15 December 2023
Our ref: MDJAC-23.008-REB-01A

RE: Residential development of 55 dwellings with vehicular and pedestrian access, car parking, open space, play space, landscaping, and all other associated works at Land South of Hanlye Lane, Longacre Crescent, Cuckfield, West Sussex.

Figure 2: screen print of the BGS viewer, showing the trees' approximate location (blue dot).

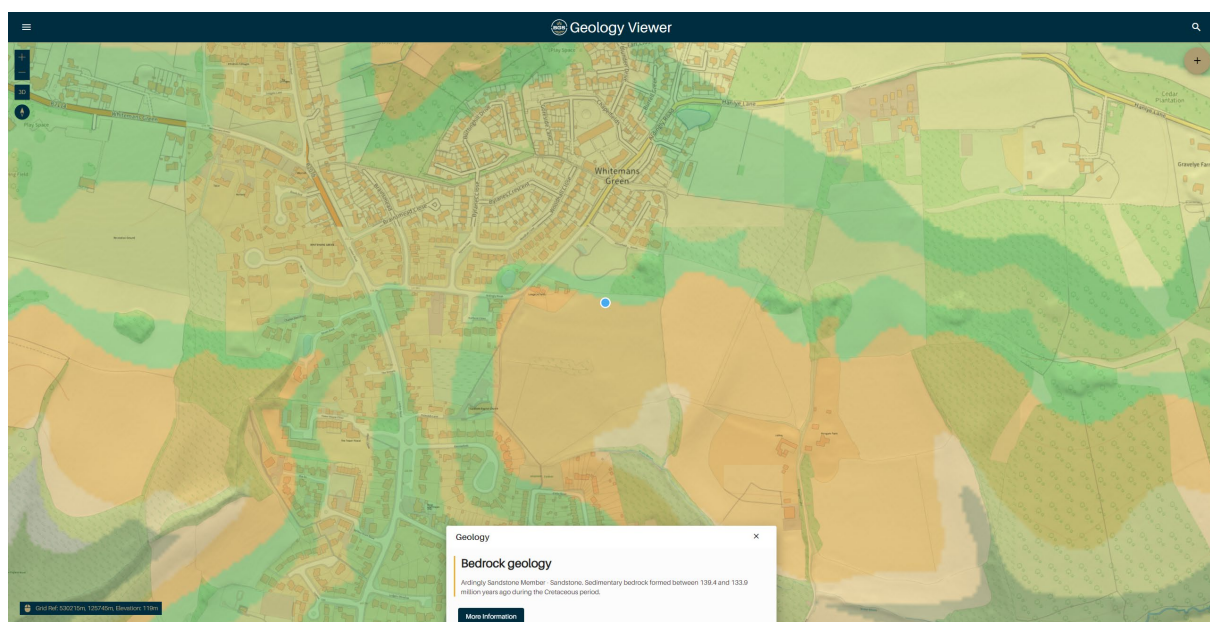
'One tree and 3 groups of trees are to be removed, including a cat B group of protected Scots pines. Is there no way to accommodate these within the development?'

- 6.6. I have referred to the British Geology Survey (BGS) dataset for the area (British Geology Society, 2023), which suggests that there are large sections of predominantly clay soil to the north of the site, and predominantly sandy soils to the south. The trees in question are located broadly on the transition between the two.

- 6.7. Pine is one of tree genera where the taproot can be retained into maturity (Roberts, et al., 2006), and it often forms a complex but shallow root system architecture; and this root architecture has been shown to be a major factor in determining anchorage failure during storms in nursery stock (Dorval, et al., 2016). Assuming that these root architecture principles are applied to the trees in question, either by dense clay preventing deep root formation and penetration, or by the need for many shallow roots to provide anchorage within a sandy, friable soil, disruption within the RPAs of these trees would likely occur within 1.5m of the trunk and could foreseeably and reasonably result in an increased likelihood of anchorage failure caused by root damage or loss. Consequently, it is not possible to safely retain any of the trees within the current layout.
